SUBJECT: DOE-NRC TECHNICAL MEETING SUMMARY

Enclosed is a summary of the DOE-NRC meeting held in San Francisco, California on October 16-18, 1984 at the office of Woodward-Clyde Consultants. The meeting was a review of geophysical data for the Paradox Basin.

NRC DATA REVIEW OF GEOPHYSICAL DATA FOR THE PARADOX BASIN  
16 to 18 October, 1984  
Woodward-Clyde Consultant office  
San Francisco, CA

WOODWARD-CLYDE  
PARADOX BASIN  
SAN JUAN CO., UTAH

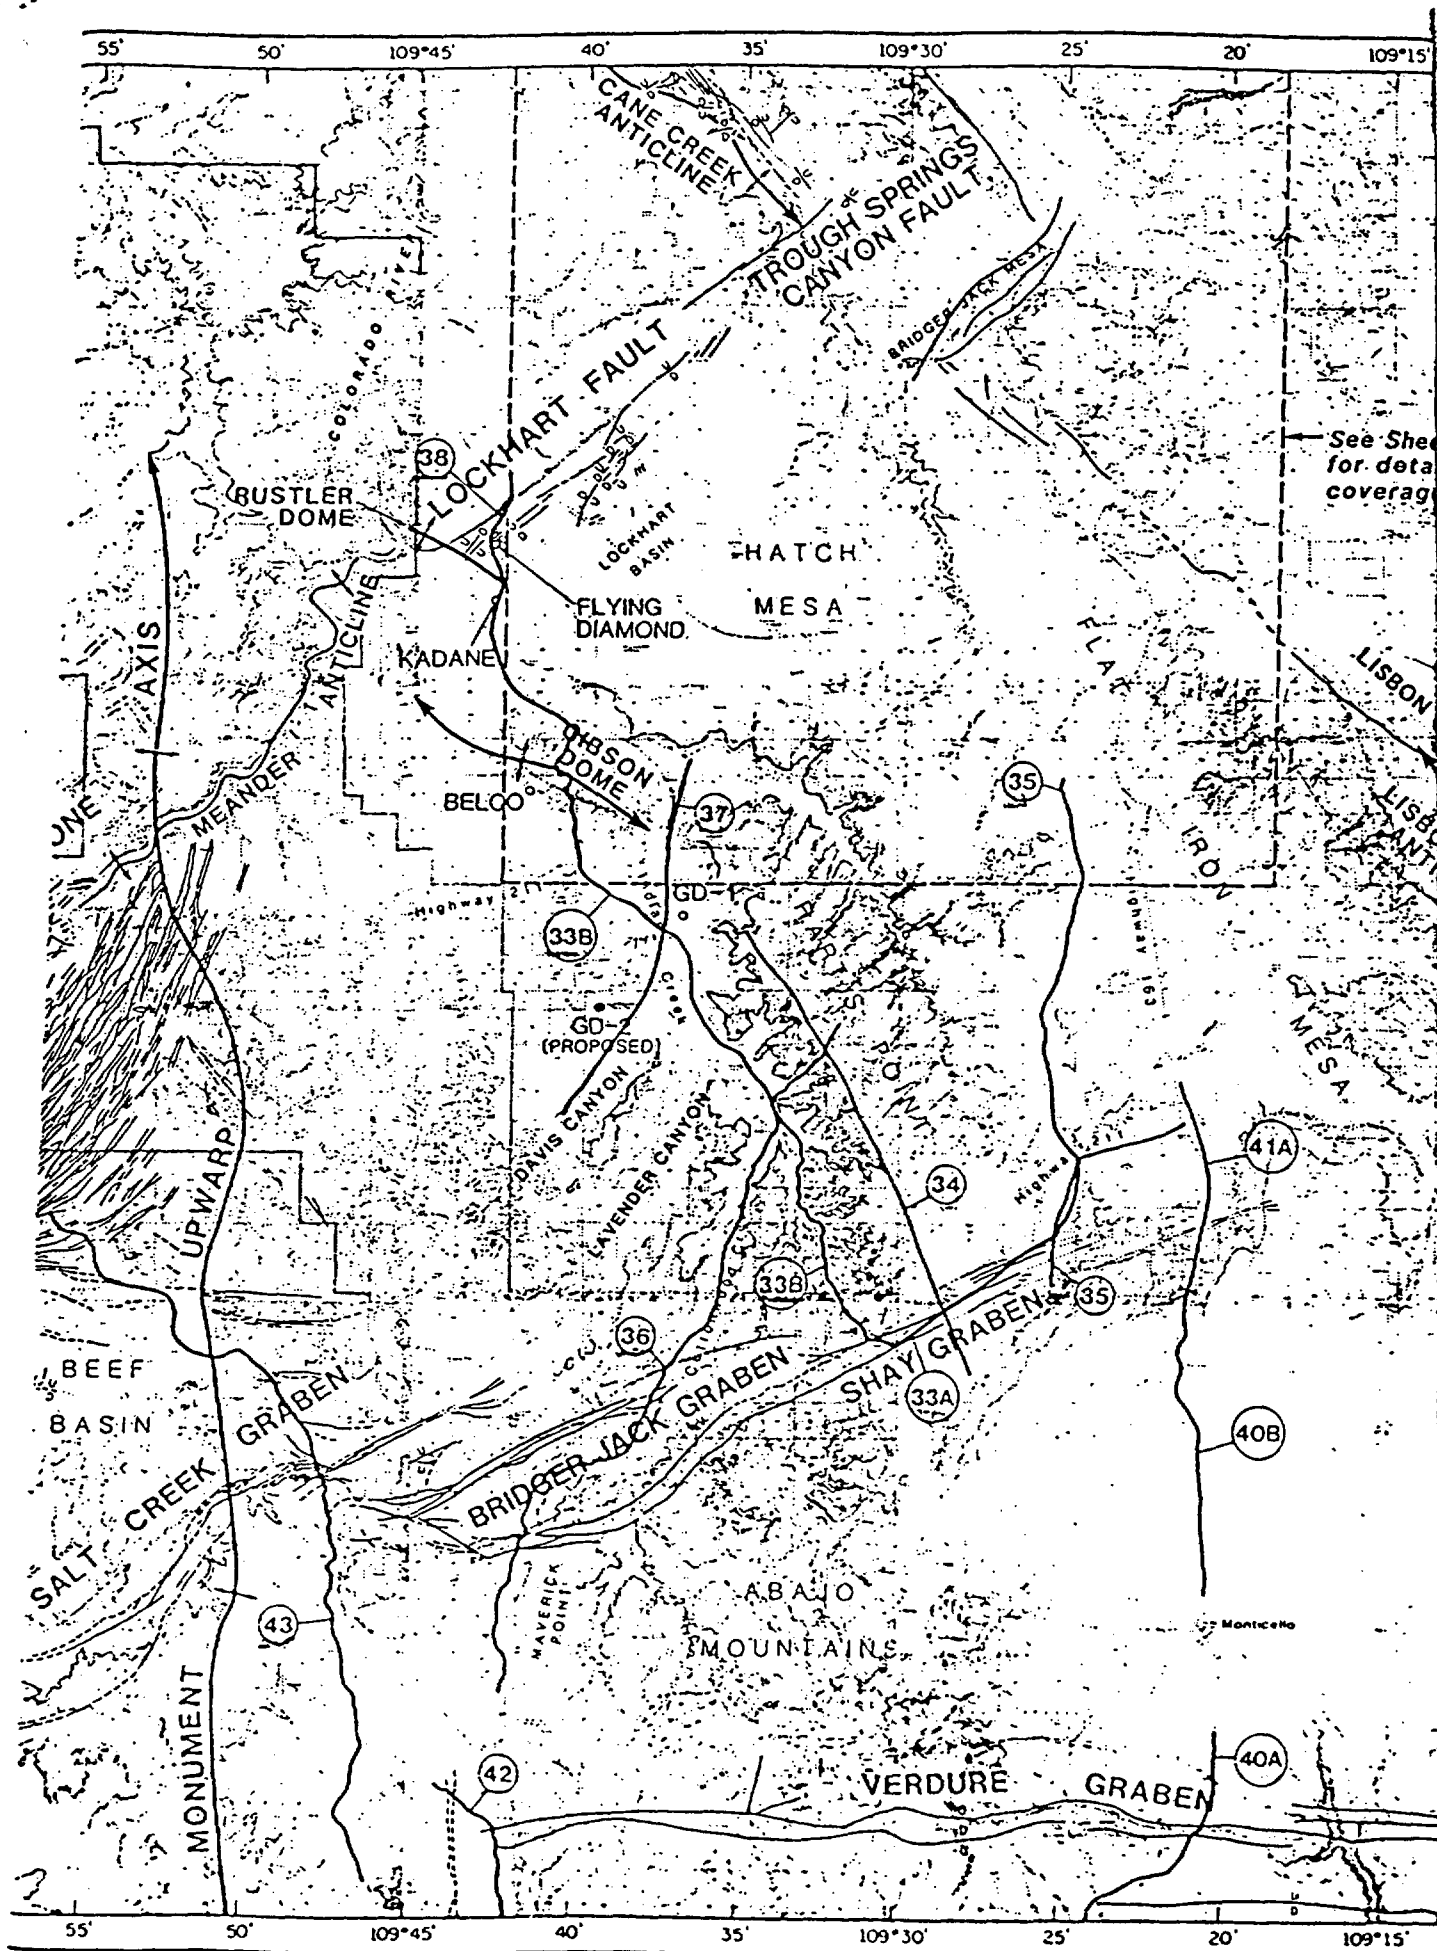
NORMAL DATA PROCESSING USED. SEE ATTACHED HEADER SHEET  
EXAMPLE FROM LINE 37 DAVIS CANYON AREA.
